SI B11 11 12
Engine

RECALL CAMPAIGN 12V-550: REPLACE HEX BOLT WITH INTERNAL THREAD FOR DEFLECTION PULLEY

This Service Information bulletin replaces SI [B11 11 12](#) dated July 2013.

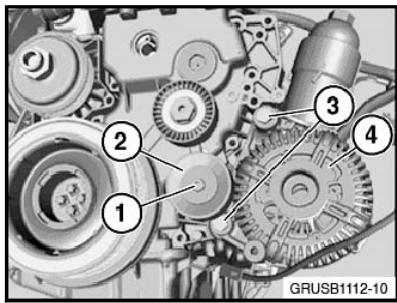
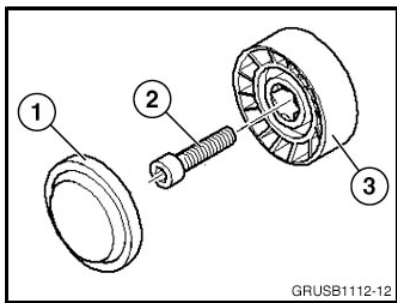
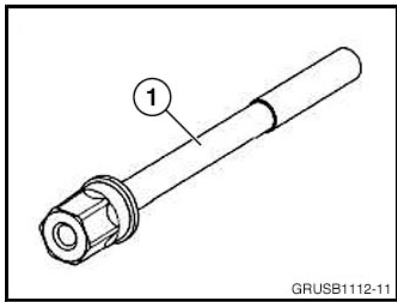
One of the alternator attaching bolts may fail. Subsequently the vehicle may lose power steering assist while driving. If power steering assistance is lost, the vehicle will remain controllable through the mechanical steering system, but with increased steering effort.

1. Replace the alternator and deflection pulley mounting bolt. Use repair instruction 12 31 020 "Removing and installing/replacing alternator (M57TU, M57T2)" to access the deflection pulley mounting bolt. Do not remove the alternator.
2. For better accessibility the fan cowl and the upper cross member have to be removed as per repair instruction 17 11 035 Removing and installing/replacing fan cowl with electric fan (M57T2). When reinstalling the cross member new bolts are required.

<p>GRUSB1112-10</p>	<p>3. Remove cover (1) from deflection pulley (2) to access the mounting bolt.</p>
 <p>GRUSB1112-12</p>	<p>4. Remove the deflection pulley mounting bolt (2) to remove the deflection pulley (3).</p> <p>Overview:</p> <p>Cover for deflection pulley (1)</p> <p>Deflection pulley mounting bolt (2)</p> <p>Deflection pulley (3)</p>
 <p>GRUSB1112-11</p>	<p>5. Remove and replace the alternator bolt with P/N 12 31 8 574 809 (M10x125). Do not remove the alternator.</p> <p>IMPORTANT!</p> <p>Bolt Torque Specification:</p> <p>Torque the new bolt to 38 Nm initial torque, and then angle torque the bolt to an additional 180°.</p> <p>Reassemble the vehicle.</p>
